Discussion of MBARI Umbilical Options Proposed by Cortland Fibron

Email from Neil McAdam dated 8 October 2010

**Figure 1
Failure #3 after Cleaning of the Fault**

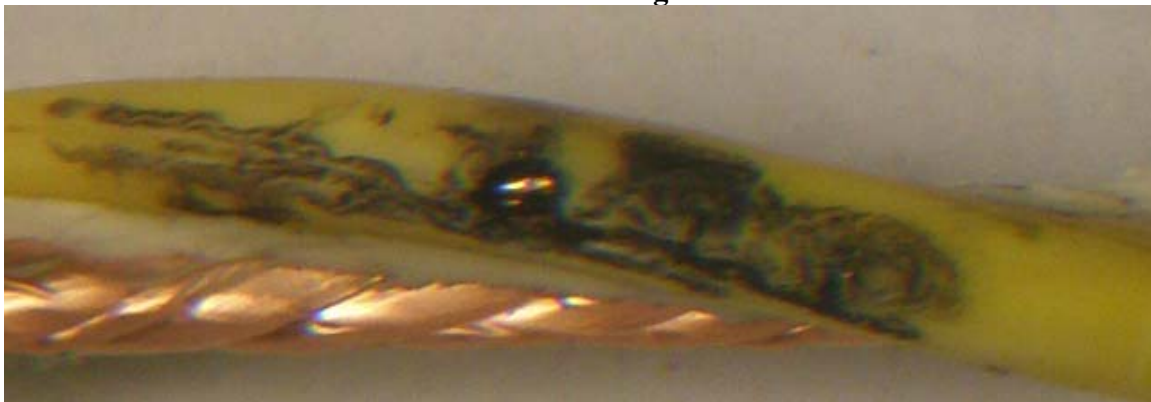
In this failure, the actual fault location is clearly between the power cable insulation and the fiber optic steel tube. After cleaning the fault location, the actual fault location does not show any mechanical determination, but only the markings from the fiber optic steel tube, see Figure 1.

It appears the cable insulation was heated by the fault current. Note the indent into the insulation following the line where the fiber optic tube was located along the insulation. Also note the discharge patterns coming off the fiber optic line indicating electrical discharges prior to the failure. Additional insulation thickness and jacketing the fiber optic tube will make a substantial improvement in the stress distribution at the interface between the cable insulation and the fiber optic tube.

As proposed in Option 2, the power cable insulation thickness would be increased and each fiber optic steel tube jacketed with the same material as the power cable insulation.
